Bathrooms	<input type="checkbox"/> Denied	Use Group: 5-1	Type: 2
Proposed Project Description: Selective demo of existing space. Interior fit-up for storage units & ADA compliant Bathrooms			<i>See Conditions</i> Signature: <i>Carca Case</i>	<i>DBL-2003</i> Signature: <i>JMB 10/8/08</i>	
			PEDESTRIAN ACTIVITIES DISTRICT (P.A.D.) Action: <input type="checkbox"/> Approved <input type="checkbox"/> Approved w/Conditions <input type="checkbox"/> Denied Signature: _____ Date: _____		
Permit Taken By: Idobson	Date Applied For: 07/15/2008	Zoning Approval

RE: Partial Site Plan Exemption, 217 Read Street - Self Storage

READ STREET SIDEWALK IMPROVEMENT PLAN
READ STREET SELF STORAGE
GRONIN PROPERTIES LLC.

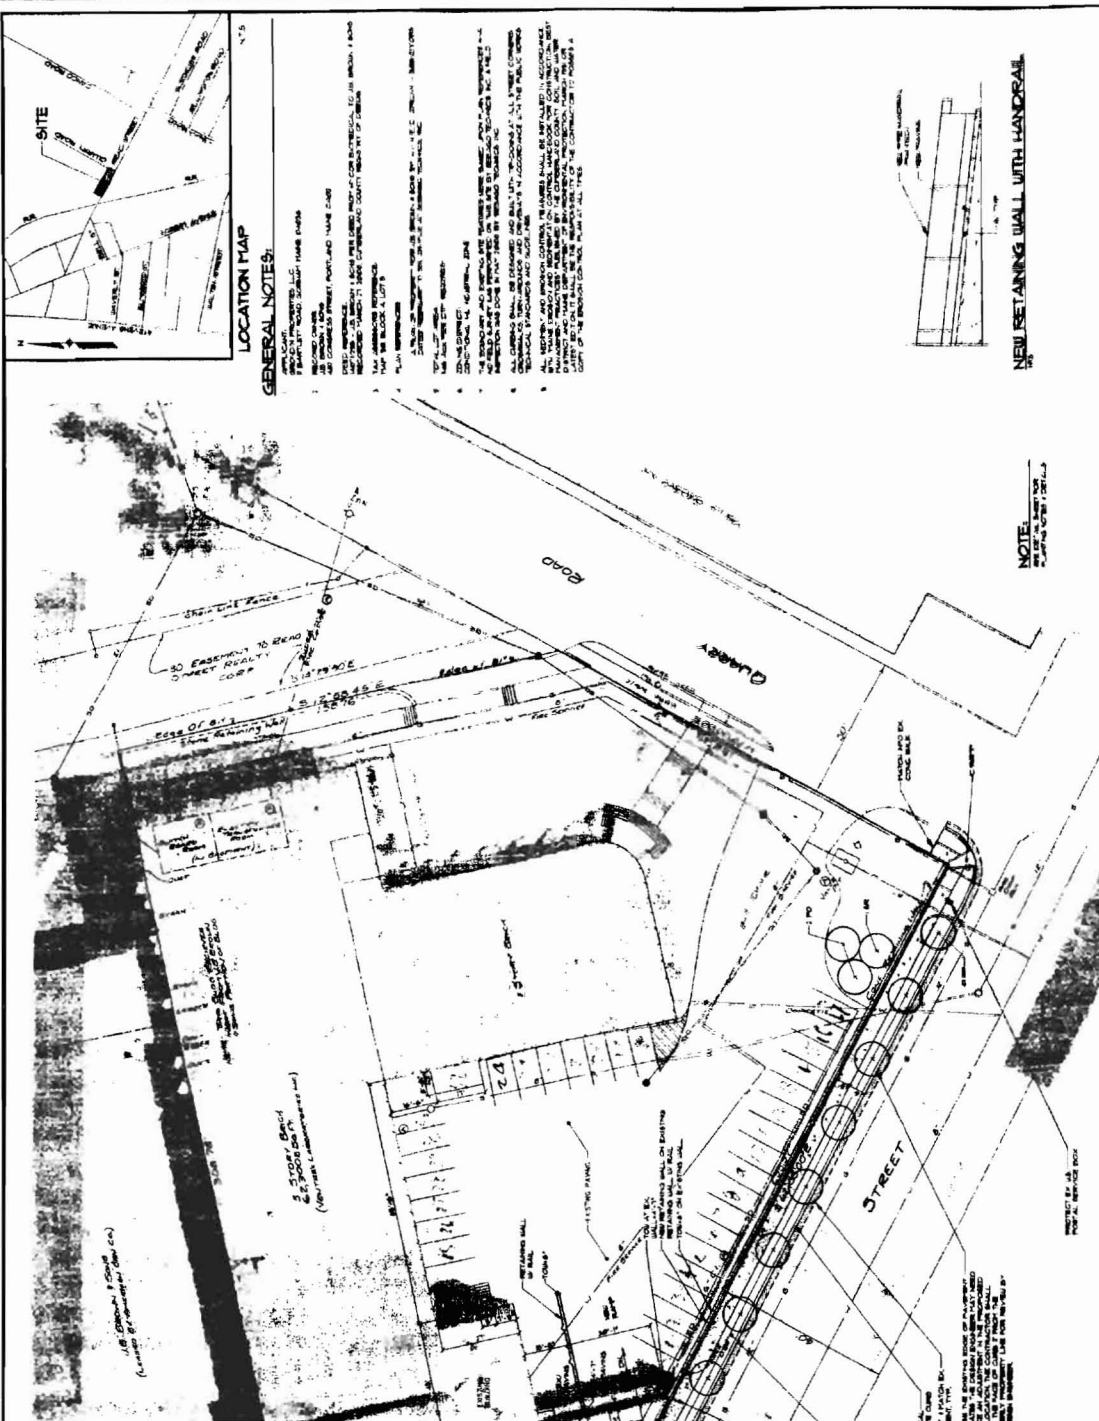
1. Install granite curb and sidewalk along the Read Street frontage.
2. Install ten (10) street trees (green ash) along Read Street frontage.
3. Install additional landscape screening to buffer loading dock area.
